SUBJECT: EPA Comments on “DRAFT REPORT - Dam Safety Assessment of CCW Impoundments: TVA Paradise Fossil Power Plant”

Re: Response to Recommendations
USEPA Impoundment Assessment DRAFT Report
Paradise Fossil Plant (PAF)
Muhlenberg County, Kentucky

TENNESSEE VALLEY AUTHORITY (TVA) – COMMENTS ON COAL ASH SITE ASSESSMENT ROUND 11 DRAFT REPORTS FOR ALLEN (ALF), BULL RUN, (BRF) COLBERT (COF), CUMBERLAND (CUF), GALLATIN (GAF), JOHN SEVIER (JSF), JOHNSONVILLE, (JOF) KINGSTON (KIF), PARADISE (PAF), SHAWNEE (SHF), WATTS BAR (WBF), AND WIDOWS CREEK (WOF) FOSSIL PLANTS

Paradise Fossil Plant, Scrubber Sludge Complex. Cross Section G used to perform seismic analysis.

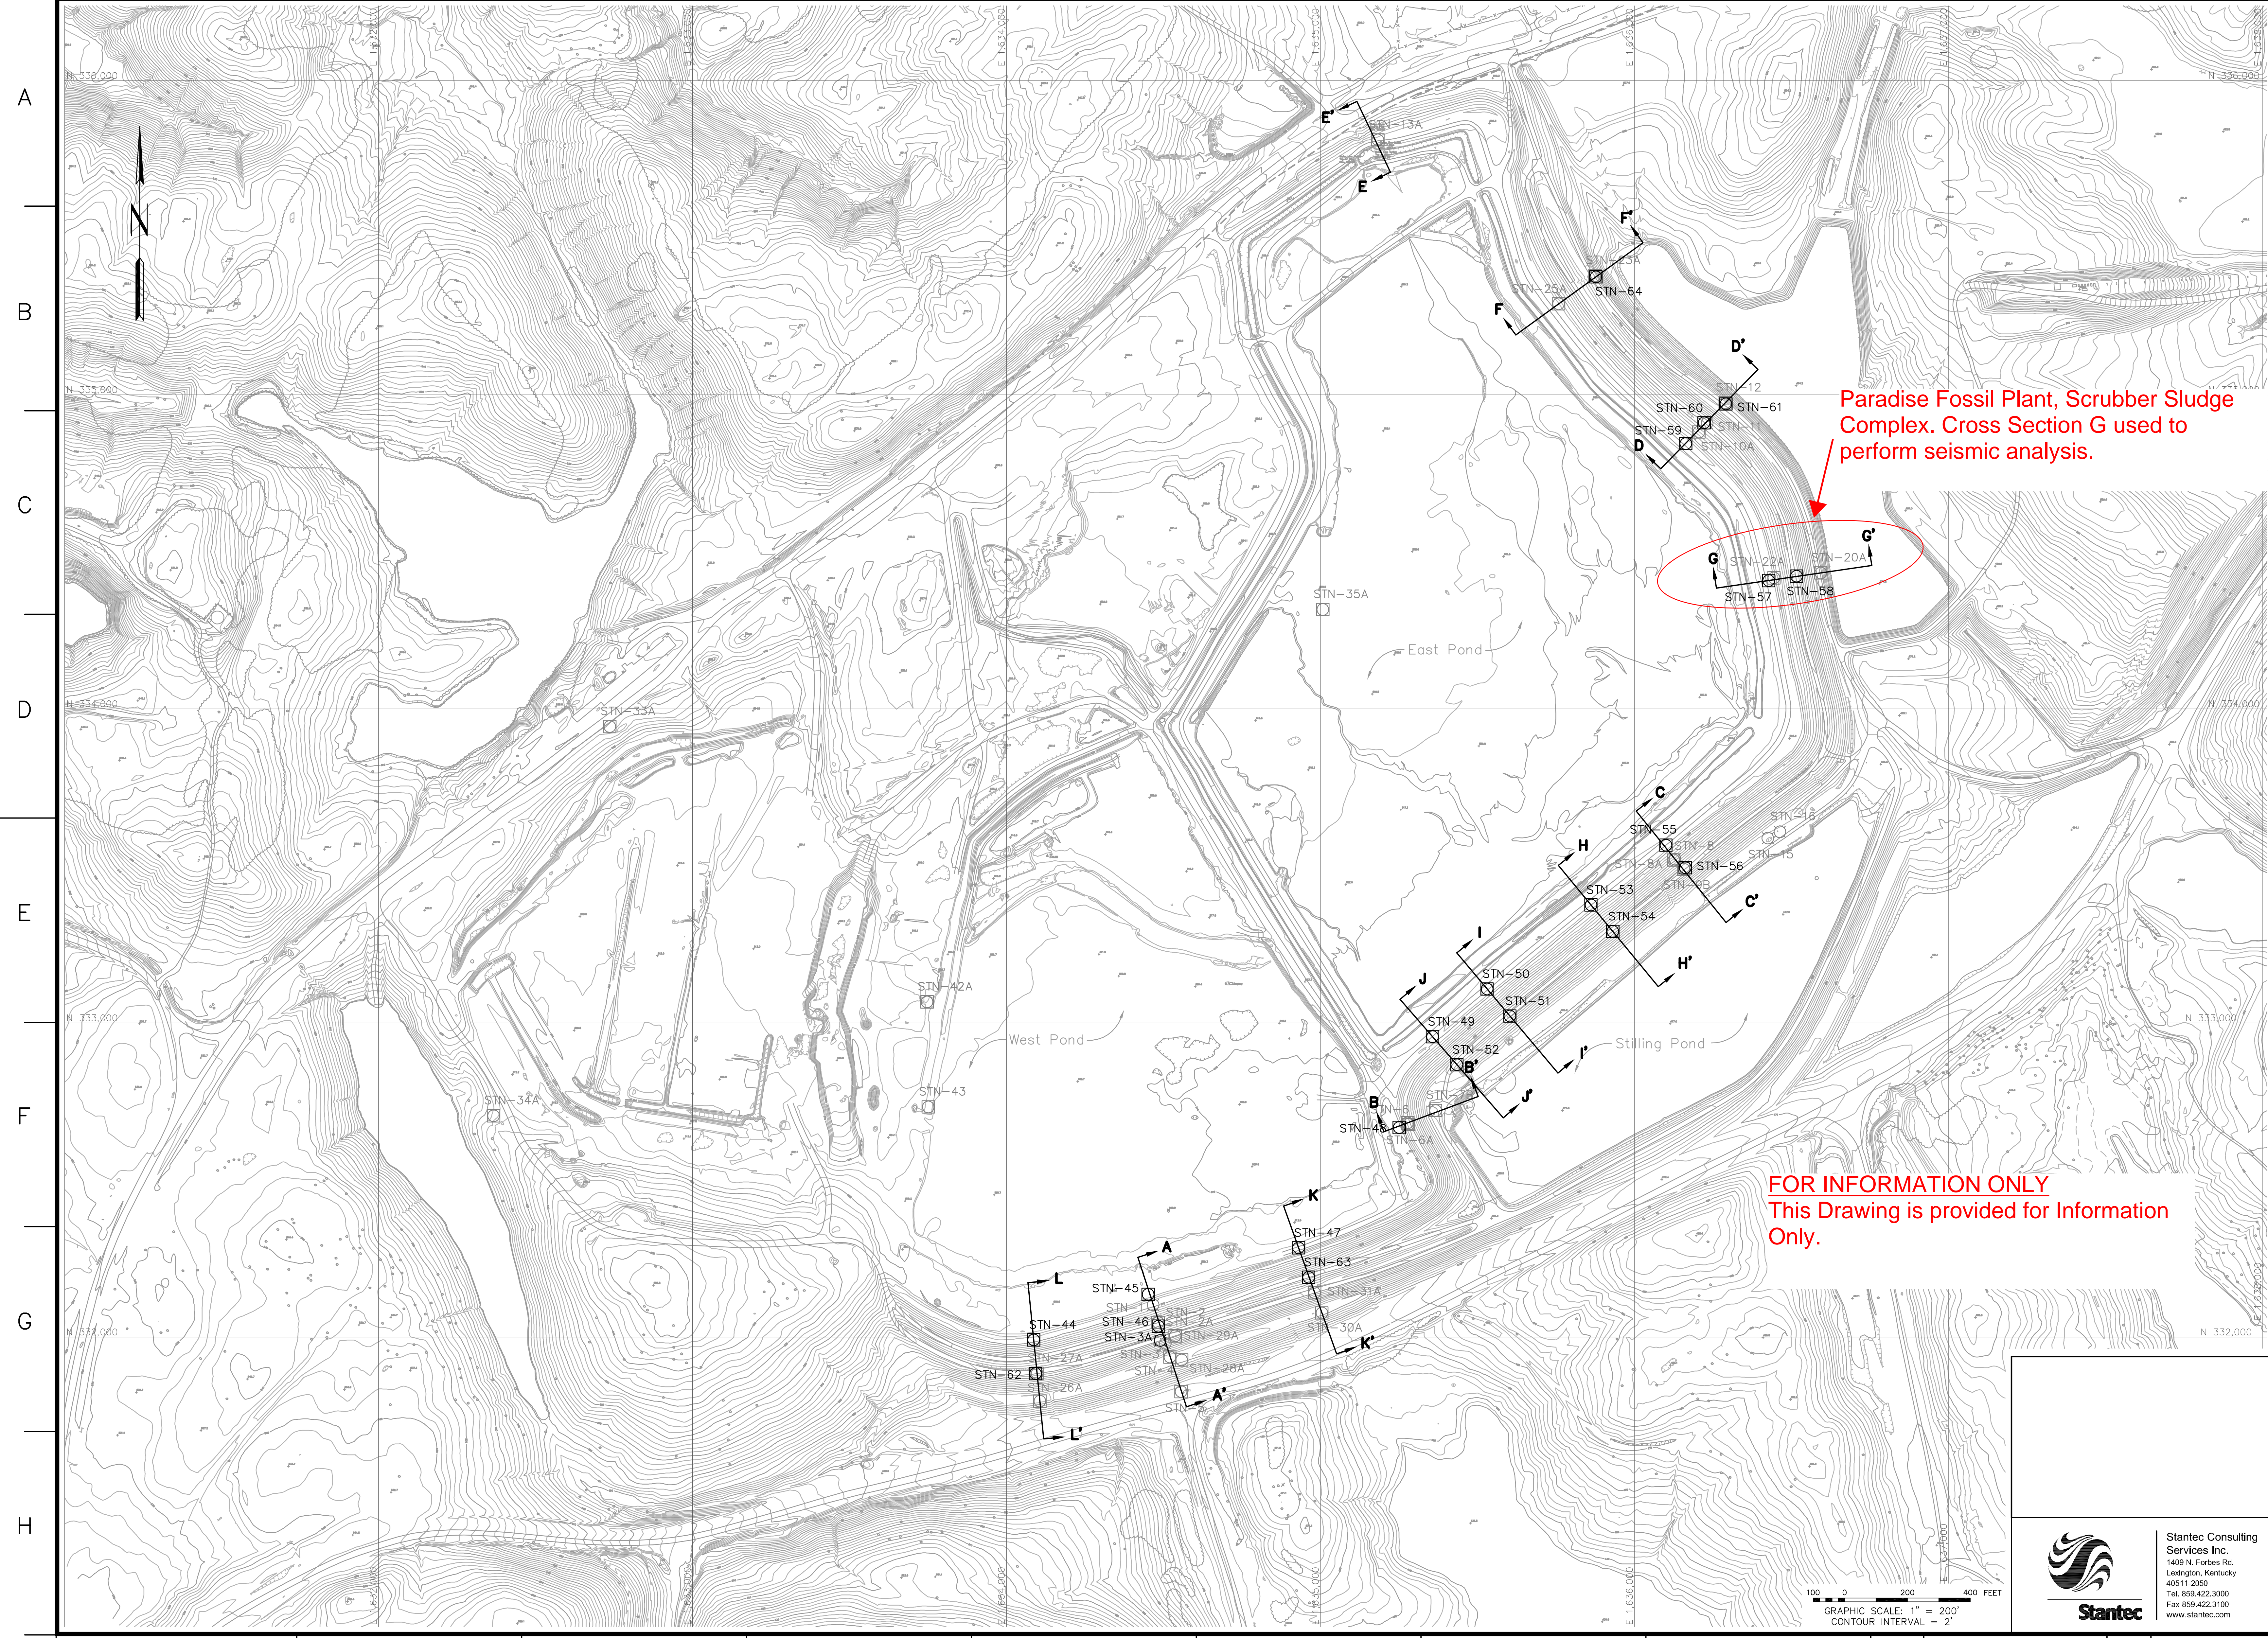
O'Brien and Gere Report Section 6.2 – Scrubber Sludge Complex Heading: Perform liquefaction potential analysis to determine if additional stability analyses are warranted.

Stantec Response: Stantec performed a liquefaction potential assessment based on ground motion estimates for the 2,500-year earthquake scenarios, Standard Penetration Test borings, and corresponding laboratory test results. A description of the methodology and the results (ground response analysis and factor of safety against liquefaction versus elevation) are attached. Consistent with previously submitted seismic stability analyses, Section G was analyzed. The results show that liquefaction will not occur for the 2,500-year earthquake; therefore, additional stability analysis is not needed.
